Deck Repair

CODE COMPLIANCE: 2021 INTERNATIONAL EXIST BLDG CODE 2923 S. MERIDIAN ST (BLDG H)

R-2 OCCUPANCY MULTI-FAMILY 2 STORY APARTMENTS

(Construction Plans, Sheet A1.1)

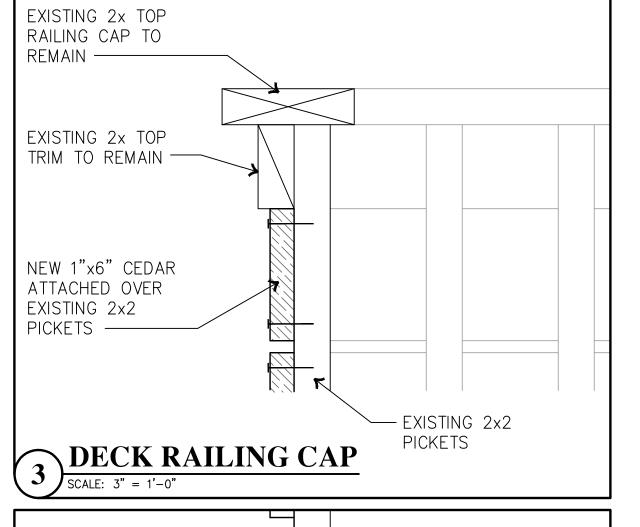
Determine the minimum required specifications for deck beams, posts, post bases, post caps and footings if replacements are necessary. Given the work already completed and the stop-work order in place, establish a clear benchmark to assess the completed work and provide clarity for future construction and inspection, minimizing any potential ambiguities.

Updated all details and notes as needed to reflect the requested information.

(Construction Plans, Sheet A1.1)

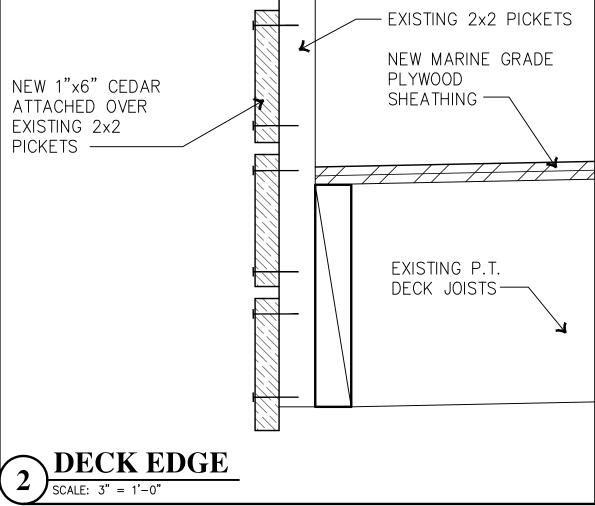
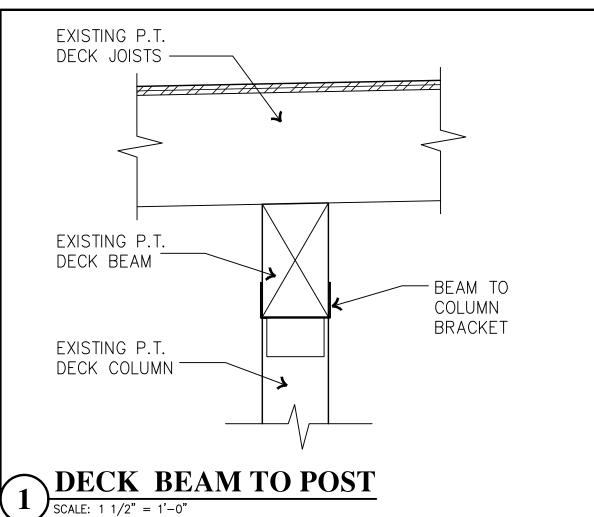
Deck joists appear to be sloped to drain off of the cantilevered side of each deck based upon details 1 and 2. Detail 2 shows the installation of the 1x6 cedar board over the existing 2x2 balusters. detail or notate how the 1x6 cedar will be installed to prevent drainage and water accumulation on the deck surface.

(Construction Plans, Sheet A1.1)

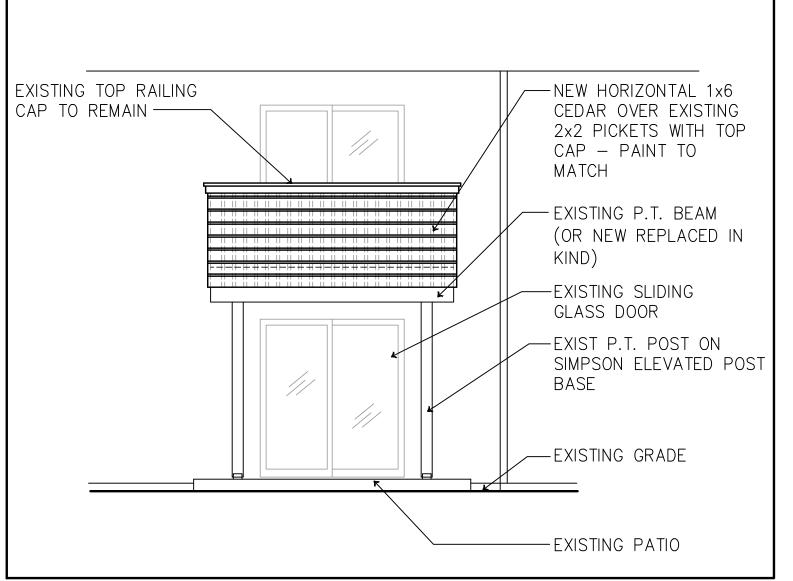
Add a notation on either Sheet A1.0 or A1.1 that contractor shall verify the integrity of balusters prior to the installation of the 1x6 cedar. Establish the parameters of the balusters replacement to include type, grade and nailing pattern.
